UNITED STATES
NUCLEAR REGULATORY COMMISSION
WASHINGTON, D. C. 20555

October 4, 1989

These amendments approve changes to Technical Specification Figure 3.2-2 which depicts the normalized heat flux hot channel factor as a function of core height.

SAFETY EVALYATION BY THE OFFICE OF NUCLEAR REACTOR REGULATION
RELATED TO AMENDMENT NO. 34 TO FACILITY OPERATING LICENSE NO. NPF-37,
AMENDMENT NO. 34 TO FACILITY OPERATING LICENSE NO. NPF-66,
AMENDMENT NO. 22 TO FACILITY OPERATING LICENSE NO. NPF-72,
AND AMENDMENT NO. 22 TO FACILITY OPERATING LICENSE NO. NPF-77
COMMONWEALTH EDISON COMPANY
BYRON STATION, UNITS 1 AND 2
BRAIDWOOD STATION, UNITS 1 AND 2
DOCKET NOS. 50-454, 50-455, 50-456, AND 50-457

FIGURE 3.2-2

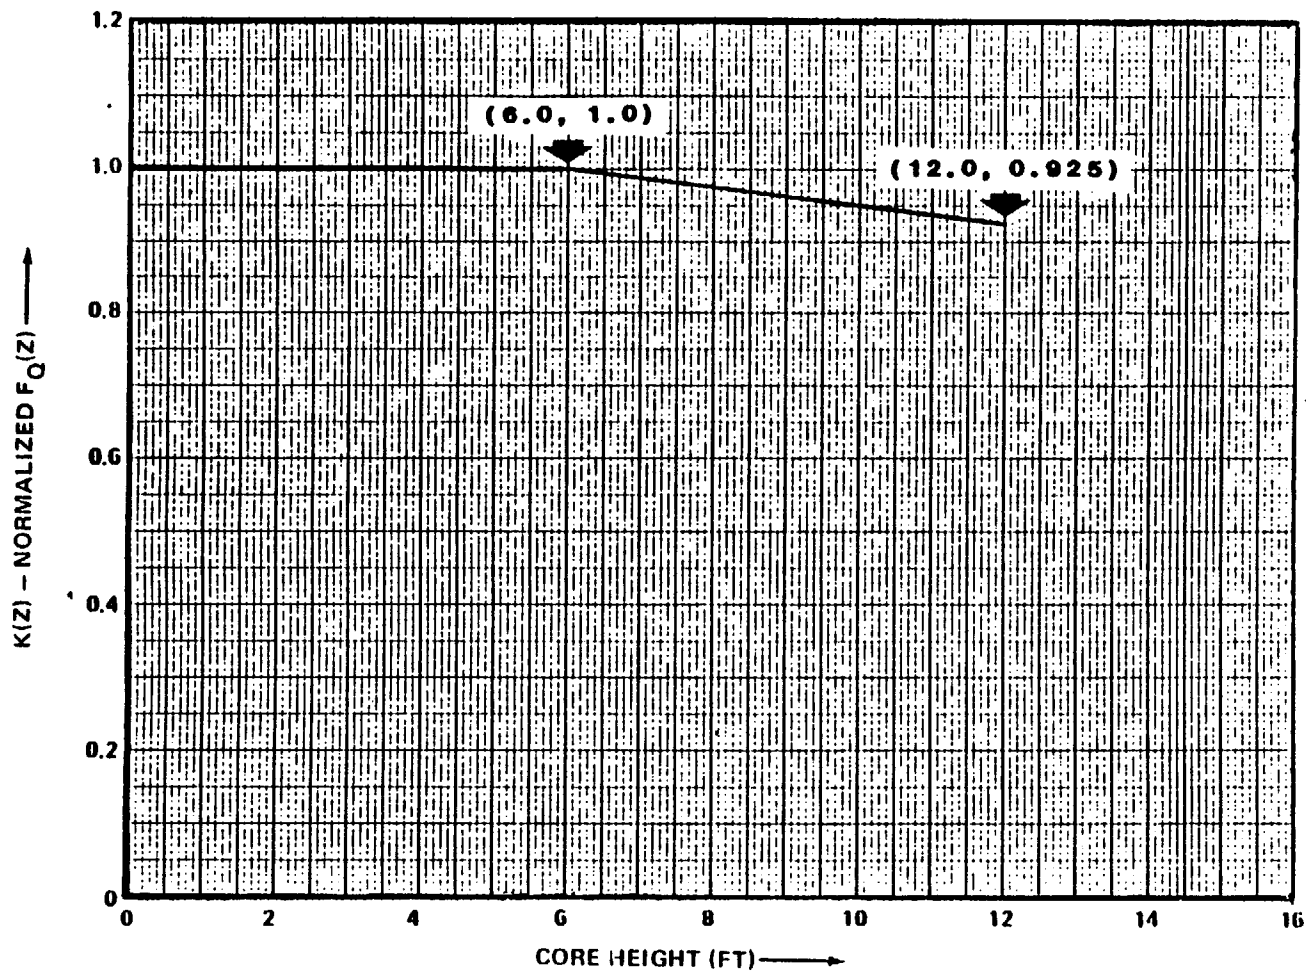
The CECO amendment request proposed to eliminate the third line segment and, in place, extend the segment defined by the points (6.0, 1.0) and (10.8, 0.94) to the 12 foot core elevation, which defined a new point (12.0, 0.925) as shown on the attached Figure 3.2-2. CECO provided a description of the analyses supporting their amendment for change of Figure 3.2-2.

Figure 3.2-2, $K(z)$ -normalized $F_0(Z)$ is a function of core height, was modified for both the Byron and Braidwood plants. The third line segment was eliminated. In place of the third line segment, the segment defined by the points (6.0, 1.0) and (10.8, 0.94) was extended to the 12 foot elevation, defined by the new point (12.0, 0.925) as shown on the attached figure. The modification was found to be acceptable as explained in Sections 2.0 and 3.0.

The staff has found the modification made to the Figure 3.2-2 $K(z)$ curve to be acceptable since the analyses on which it is based used acceptable codes, and the results of these analyses meet the criteria of 10 CFR 50.46:
